| APPLICATION NO. | FILING DATE | FIRST NAMED INVENTOR | ATTORNEY DOCKET NO. | CONFIRMATION NO. |
|--|-------------|----------------------|---------------------------|------------------------|
| 10/568,283 | 09/14/2006 | Masanori Wada | 2006-0184A | 3298 |

| Office Action Summary | Application No. | Applicant(s) | |

DETAILED ACTION

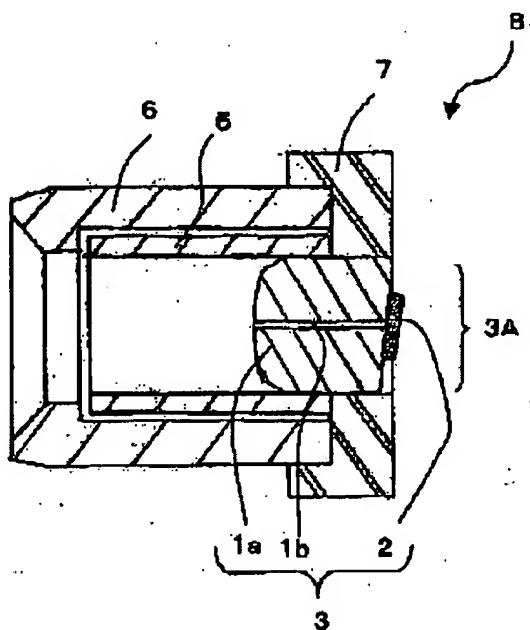
In re claim 1, Morooka discloses an optical receptacle (Figures 1-3) comprising:

a precision sleeve 5;

a stub **3** provided with an optical fiber **1b**, said stub **3** being inserted into one end of an inner hole of the precision sleeve **5**;

a sleeve holder 6/7 fixed to an outer periphery of the precision sleeve 5 by press-fitting or through an adhesive (Document AJ: page 4, paragraph [0004] and page 7, [0043]);

wherein an outer peripheral face of the stub 3 and the inner hole of the precision sleeve 5 have a surface roughness "Ra" value of 0.2 micrometers or less (Document AJ: page 7, paragraph [0036]). Figure 1 of Morooka is reproduced below.

In re claim 4, Morooka discloses a bore tolerance between the sleeve **5** and a ferrule **1a** of 1 micrometer or less (Document AJ: page 7, paragraph [0036]).

Thus, Morooka only differs from claims 1 and 4 in that Morooka does not disclose fixing the stub 3 to the sleeve 5 through an adhesive. Nakamura, however, teaches fixing an optical fiber ferrule 17 to a precision sleeve 15 through an adhesive 28. See Nakamura at paragraph [082].

FIG. 8

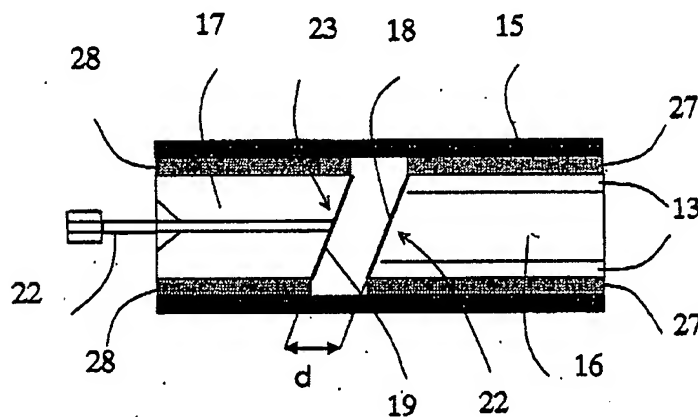
Figure 8 of Nakamura is reproduced below.

One motivation for combining Nakamura with Morooka is mentioned in paragraph [033] of Nakamura (i.e., provide "excellent mechanical and physical strengths, environmental resistance, and heat resistance"). Therefore, it would have been obvious to one of ordinary skill in the art at the time of the claimed invention to obtain the invention specified by claims 1 and 4 in view of Morooka combined with Nakamura.

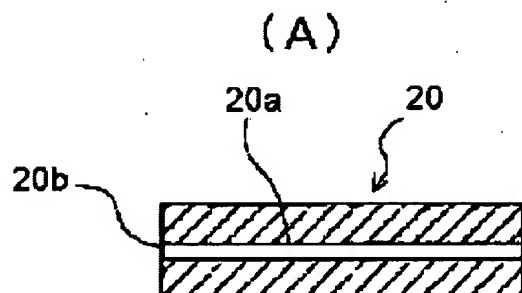
In re claims 2 and 10, Morooka combined with Nakamura only differ from the claims in that Morooka does not expressly teach that an outer periphery of his stub 3 or the inner hole of his precision sleeve 5 has a surface roughness Ra value of more than 0.2 μm and a surface roughness Ry value of 4.0 μm or less, and a difference between an average line and a peak line of surface roughness is 2.0 μm or less. Saito, however, teaches an inner hole 20a of a capillary tube 20 having a surface roughness Ra, a surface roughness Ry, and a difference between an average line and a peak line of surface roughness that overlap the values recited by claim 2. *See* Document AI, page 10, paragraph [0040]. Figure 1 of Saito is reproduced below.

Although Saito is primarily concerned with the alignment between his capillary tube **20** and an optical fiber, the same general principle would have also applied to Morooka's precision sleeve **5** and ferrule **1a**. In other words, one of ordinary skill in the art would have easily recognized that Saito's technique for optimizing alignment between an optical fiber and a cylindrical tube would also be relevant to aligning Morooka's cylindrical ferrule **1a** with Morooka's cylindrical sleeve **5**. The motivation for combining Saito with Morooka would have been to lower optical connection losses. See page 1 of Document AI. Therefore, it would have been obvious to one of ordinary skill in the art at the time of the claimed invention to obtain the invention specified by claims 2 and 10 in view of Morooka combined with Nakamura, and further in view of Saito.
